STAFF REPORT

To: University Heights City Council

Item: May 27, 2011 PUD submittal
1300 Melrose Avenue

Date: June 7, 2011

Figure 1: Existing Peak Hour Traffic Volumes

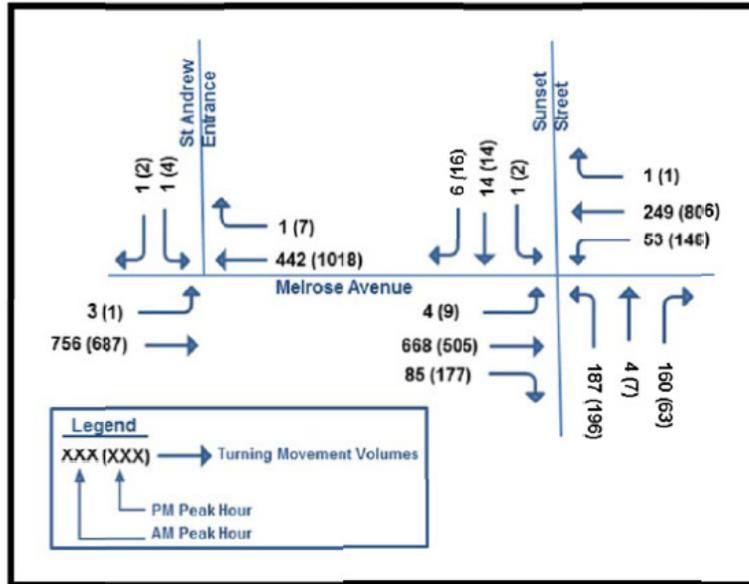
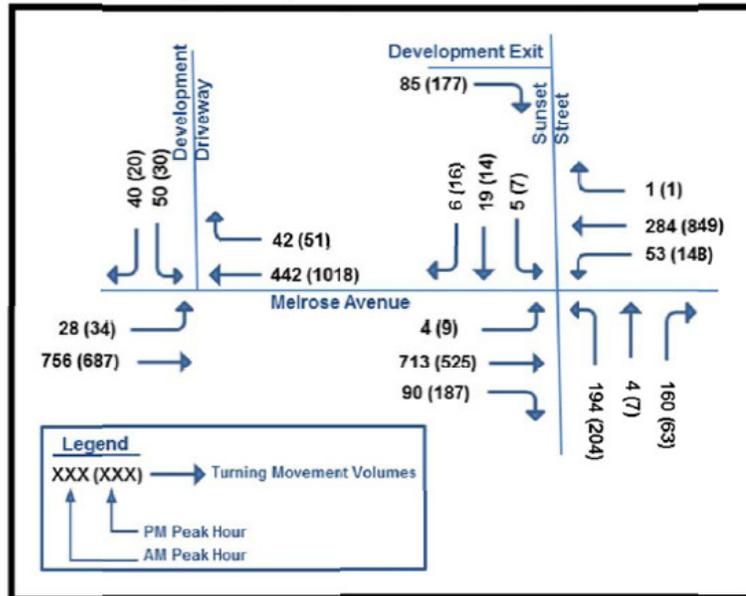
Peak hour traffic volumes for existing and proposed conditions are found in **Figure 1** and **Figure 2**. The proposed traffic distribution assumes that approximately 90% of the traffic enters/exists from Melrose Avenue and that approximately 50% of the traffic travels from/to the east on Melrose Avenue, 10% travels to/from the south on Sunset Street, and 40% travels to/from the west on Melrose Avenue.
